MFN No. 034-92
Docket No. STN 50-605
EEN-9220

Subject: **GE Responses to the Request for Additional Information on ABWR
Design for Severe Accidents**

**Response to Request for Additional Information
Pertaining to ABWR Design for Severe Accidents**

FIGURE 1

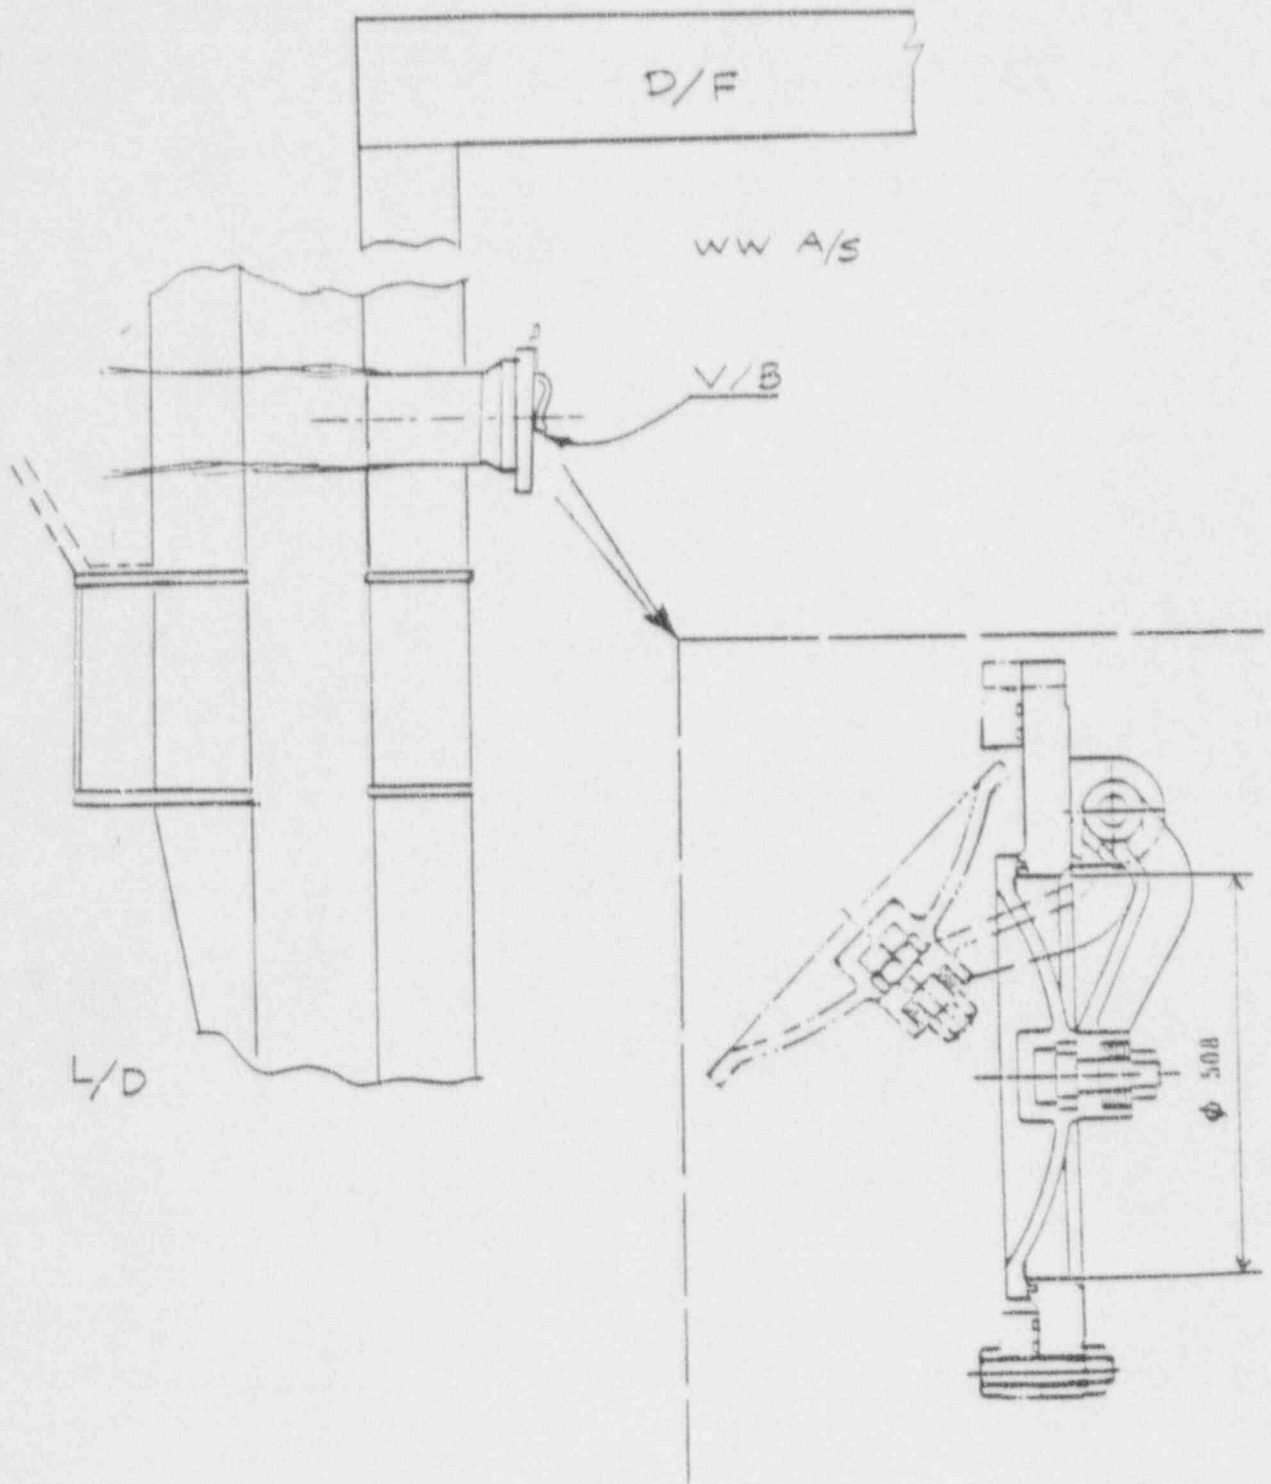
In regard to drywell/wetwell bypass, it appears that GE estimates that the drywell/wetwell vacuum breakers have a low contribution to suppression pool bypass flow effects. Please provide engineering drawings of the valves and a discussion on valve attributes which would yield expected high performance.

The analysis of suppression pool and containment bypass is presented in subsection 19E.2.3.3 of the ABWR SSAR. In that analysis it was concluded that bypass had a small contribution to overall plant risk. The vacuum breaker path dominated this (relatively small) increase. A presentation was made to the staff on October 8, 1991 which described the vacuum breakers used in ABWR and the improvements in their design over that used in past plants. A sketch of the valve taken from that presentation is shown in Figure 1. The ABWR vacuum breaker is a swing check valve which opens passively due to differential pressure across the valve, and requires no external power to actuate. The force of gravity closes the valve. It is capable of accommodating the expected repeated cyclic loading which might occur due to chugging in the Mark I and Mark II designs. The performance of the valve has been demonstrated, it is highly unlikely to stick open.

Additionally, the ABWR vacuum breakers are mounted high in the suppression pool on the pedestal wall away from the wetwell/drywell connecting vents (see Figures 1.2-3c and 1.2-3k of the ABWR SSAR). They open into the lower drywell. This arrangement location precludes the vacuum breakers from being subjected to cyclic loading due to chugging during the later part of the LOCA blowdown phase. Analysis indicates that the vacuum breakers are not subjected to any duty during the LOCA blowdown period. They are expected to open only after the blowdown is complete and either sprays are initiated or subcooled water starts spilling out of the LOCA break.
